Terry O. Brown P.E.
Civil / Transportation Engineering

Re: Oxbow Development / Coors Pavilion (St. Josephs Dr. / Coors Blvd.)

I will be resubmitting the Traffic Impact Study for the Referenced Oxbow Development / Coors Pavilion project in the future to address both the City's comments as well as the NM DOT comments. For the time being, I will address your comments to the best of my ability in this letter. Your comments were transmitted to me on March 8, 2022 in letter form attached to an e-mail. Below is a summary of your comments and my responses:

SHEET NO. C-100

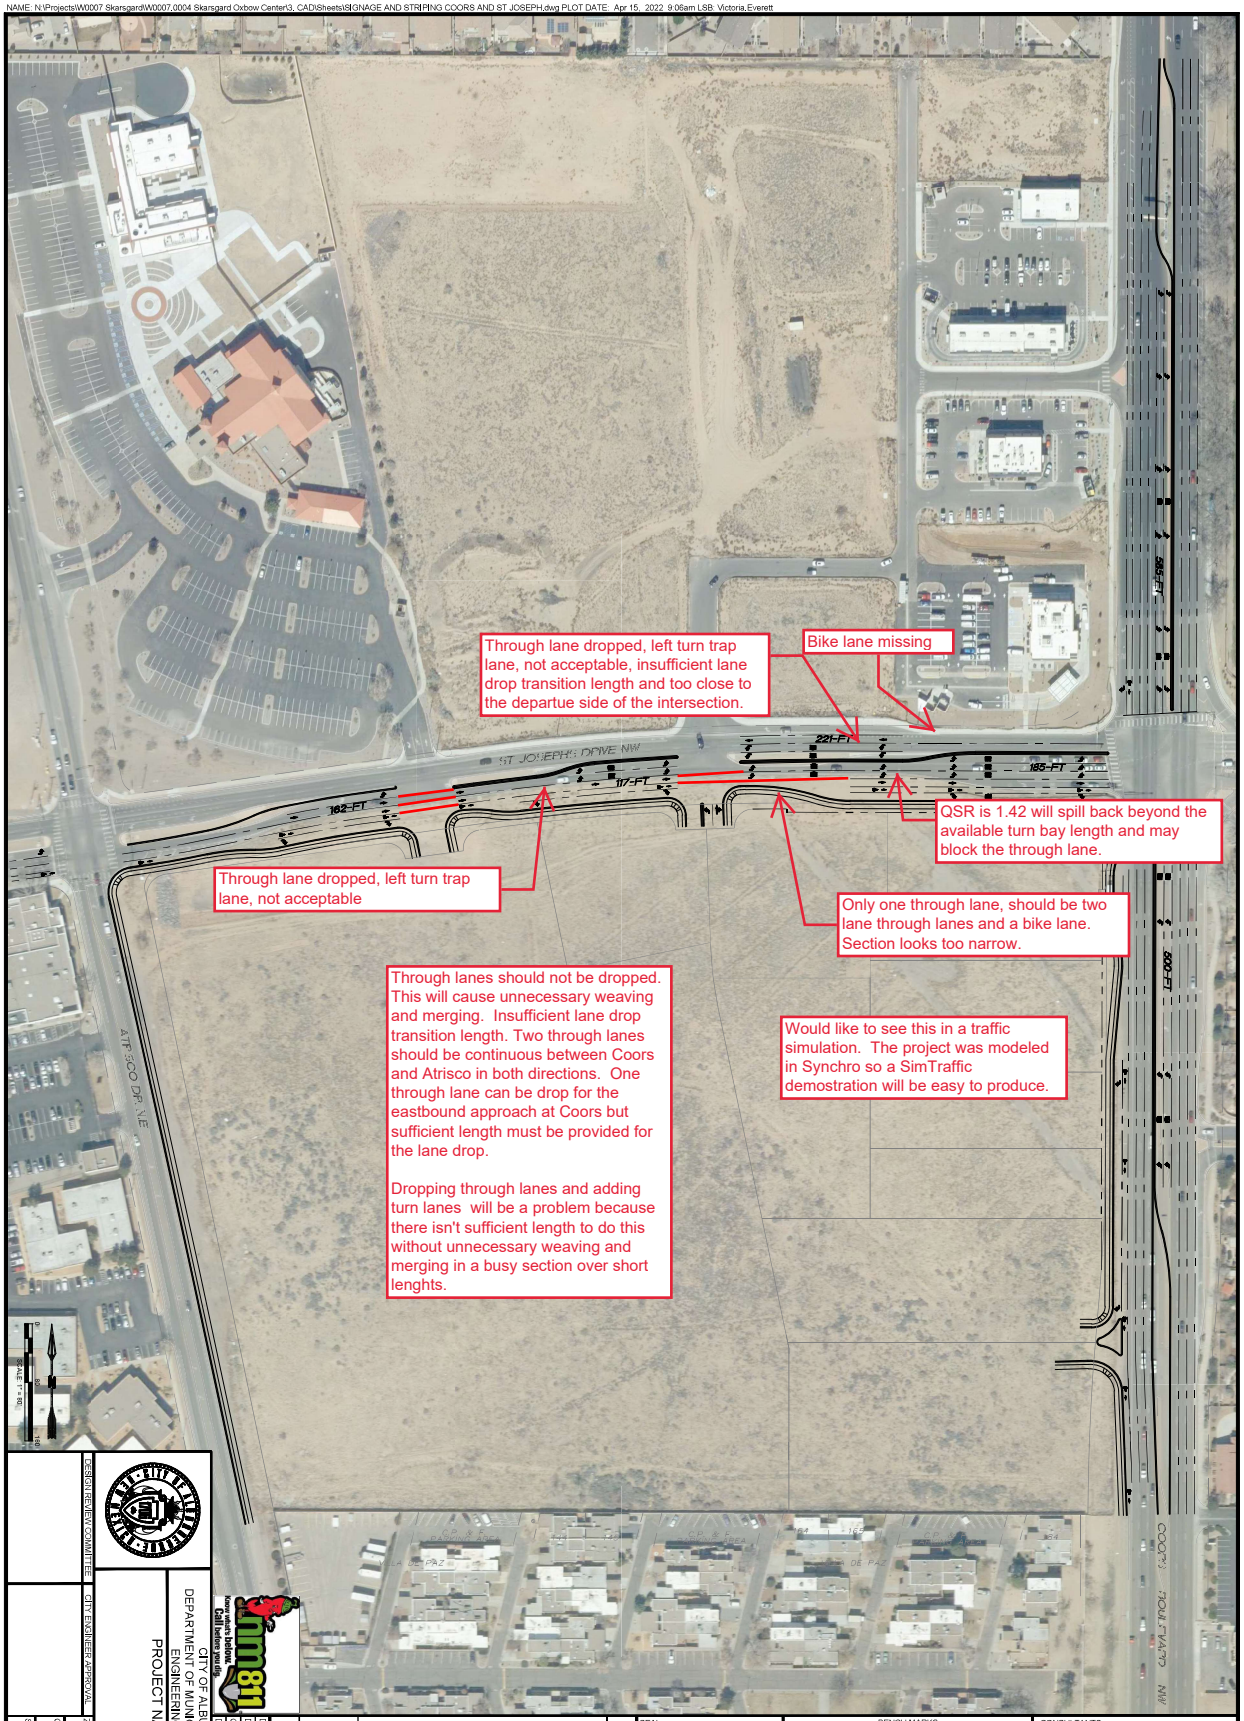
Comment: Provide a conceptual footprint to determine the available ROW and what unforeseen infrastructure impacts are anticipated i.e. traffic signal modifications / relocation …
Response: Attached is a graphic conceptual roadway plan developed by Sheldon Greer, P.E. at RESPEC Engineering that demonstrated sufficient ROW available for the recommendations in the TIS.

Comment: Provide a conceptual footprint of the main entrance to show that it will fit in the existing ROW. Add the eastbound bicycle lane with buffer.
Response: The attached graphical conceptual roadway plan demonstrates that the main entrance will fit in existing ROW and an eastbound bicycle lane is shown.
